APPENDIX 3

Compensatory Mitigation

A3.1. The Compensatory Mitigation Plan will not replace high quality resources in Pigeonroost Branch and Oldhouse Branch

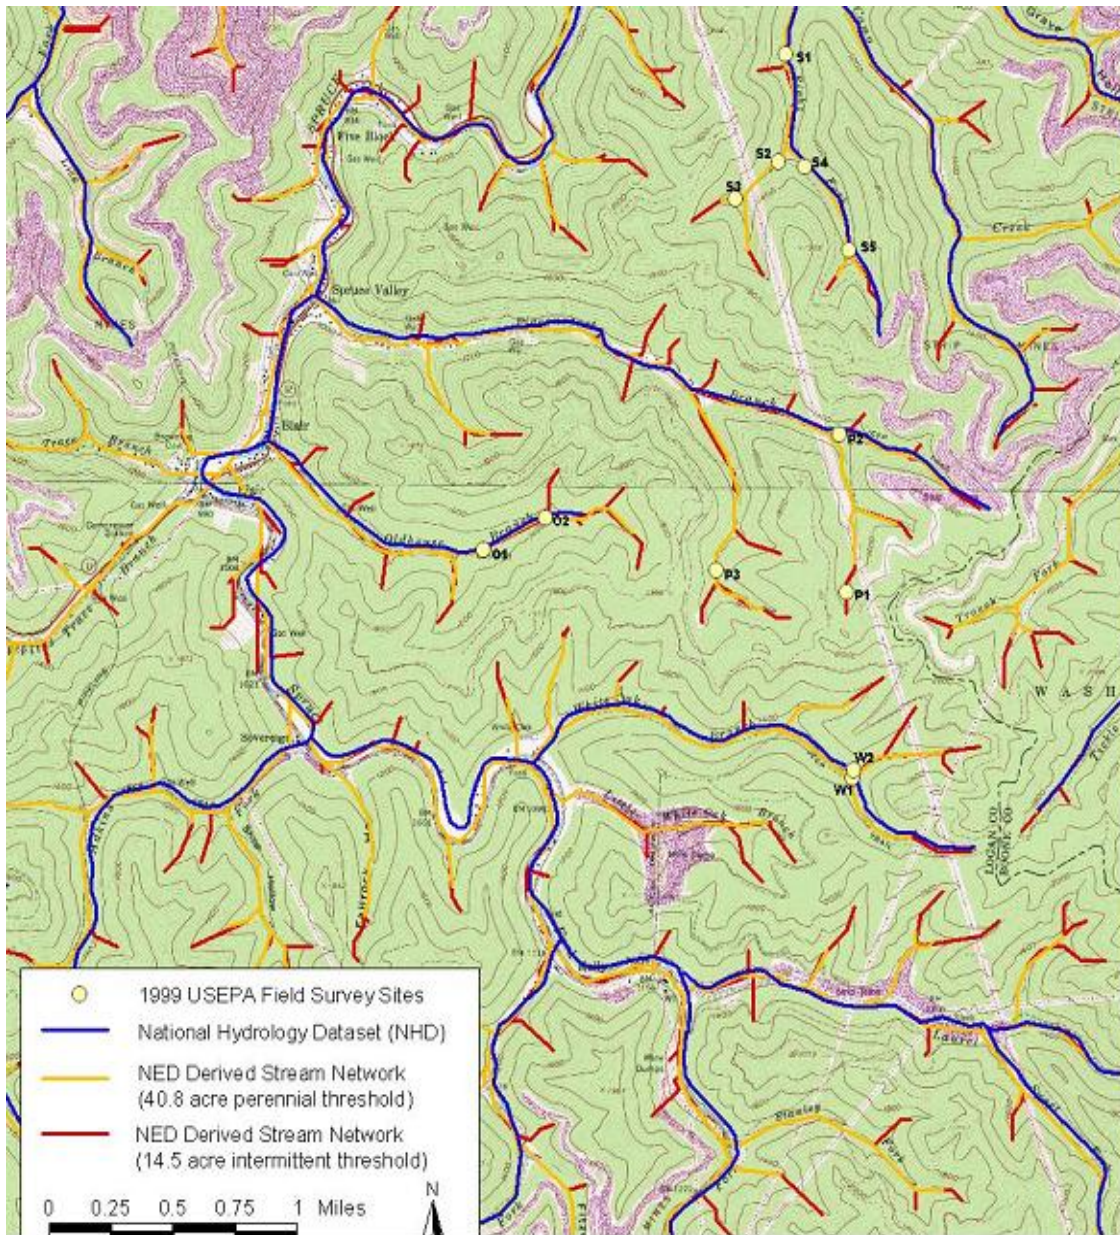
Based on these new scientific studies and previously collected field data, EPA believes that the project will impact previously misclassified segments of intermittent and perennial stream channels. An example of mischaracterization is in Oldhouse Branch. The uppermost ephemeral/intermittent delineation point, referred to as "O1" in Figure A3.1. and "T1" in CMP Exhibit 2, occurs at approximately the 255-acre watershed size. At this watershed size, EPA believes that a strong perennial stream channel is present for thousands of feet upstream of this point. Figure A3.1. shows an excerpt from a 7.5 min USGS topographic map depicting Green and Passmore (1999) study sites, overlain with Paybins (2003) drainage-area derived intermittent and perennial delineations.

EPA compared lengths of stream channel in Pigeonroost Branch and Oldhouse Branch from USGS estimates, to field delineations made by the applicant. It is EPA's determination that at point T1 in Oldhouse Branch, the applicant's demarcation for ephemeral/intermittent found in CMP Exhibit 2, there are approximately 3100 feet of unaccounted-for perennial stream upstream of that point. Moreover, in Oldhouse Branch, an additional 1100 feet in "Second Unnamed Right Tributary" (T2 in CMP Exhibit 2) likely run perennially. By adding the additional distance from T1 down to the toe of the fill, EPA believes that cumulatively there are over 7000 feet of perennial stream channel in Oldhouse Branch alone that will be filled or otherwise eliminated from direct mining impacts. This is in contrast to the less than 200 feet for the entire project as determined by the applicant.

In Pigeonroost Branch, EPA believes that additional stream lengths, which have been classified as ephemeral or intermittent by the applicants, are likely perennial waters based on biological sampling. An EPA study (Green and Passmore 1999) used the WV water quality standards methodology for determining perennial streams and was conducted during a relatively dry, late summer period. In Green and Passmore (1999), EPA categorized two types of perennial streams: Type 1 (flow and indicator biota requiring at least a 6 month life cycle) and Type 2 (non-contiguous surface flow during drought conditions but indicator biota requiring at least a 6 month life cycle). They found Type 1 conditions near the very headwaters of Pigeonroost Branch. Additionally, one site in upper Middle Fork of Pigeonroost Branch (P1 in Figure A3.1.) with a catchment area of only 15 acres was also deemed to be a Type 1 perennial stream.

Figure A3.2. Reclaimed sediment ditch: Anna Branch (Logan Co., WV).

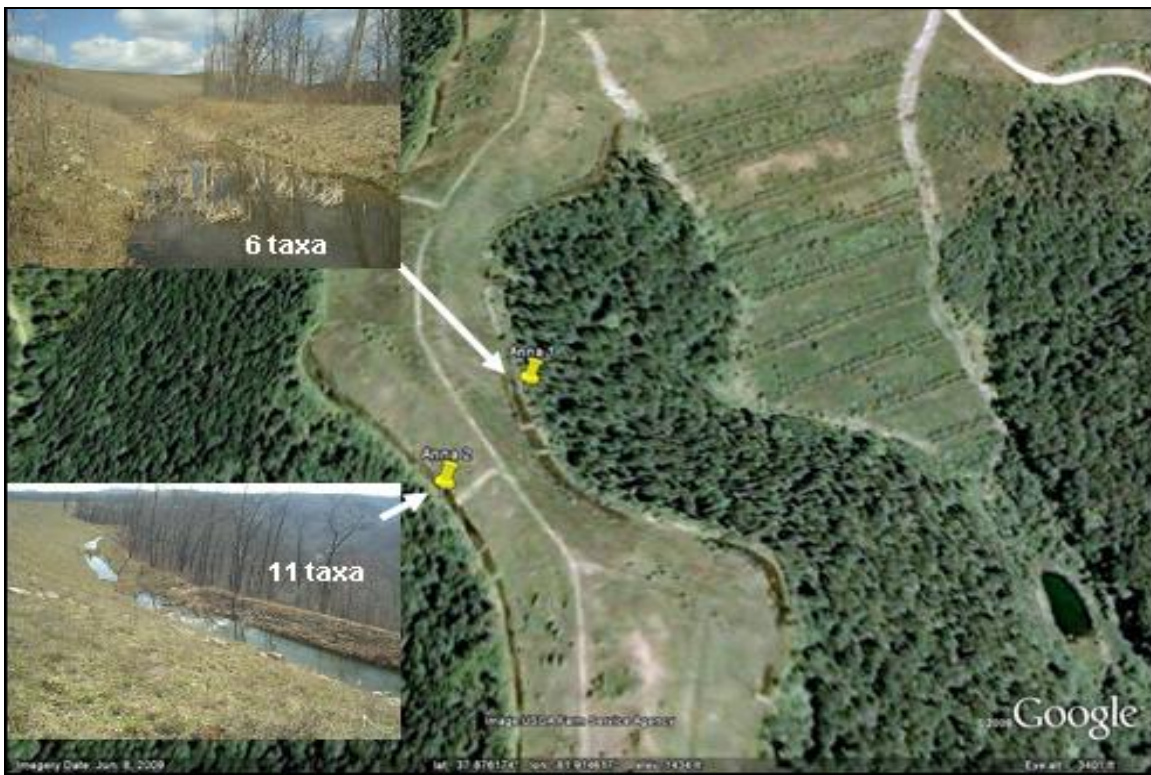
Given the current knowledge of the physical, chemical and biological conditions in several representative on-bench ditches, it is clear that the biological and chemical conditions of the buried headwater streams will not be replaced by these mitigation measures. Evidence reported below (Figures A3.2.-A3.4.) reveals that the created channels would fail to meet the conditions of the permit for most sites. Even when the sediment ditches are enhanced for benthic substrata and riparian vegetation (e.g., boulder clusters every 500-1,000 ft), the water quality will likely be so degraded that the ditches will not meet or exceed pre-mining WVSCI scores required by the permit's Special Conditions.

Figures A3.2. and A3.3. above show aerial views of examples of on-bench sediment ditches with accompanying biological and physicochemical data. Gingerich (2009) re-sampled the Hobet mine site nearly 20 years after construction and found only one EPT taxon, with in-channel conductivity still averaging $>2200 \mu\text{S}/\text{cm}$. EPA has observed the following conditions in these sediment ditches, in comparison to natural high-gradient streams:
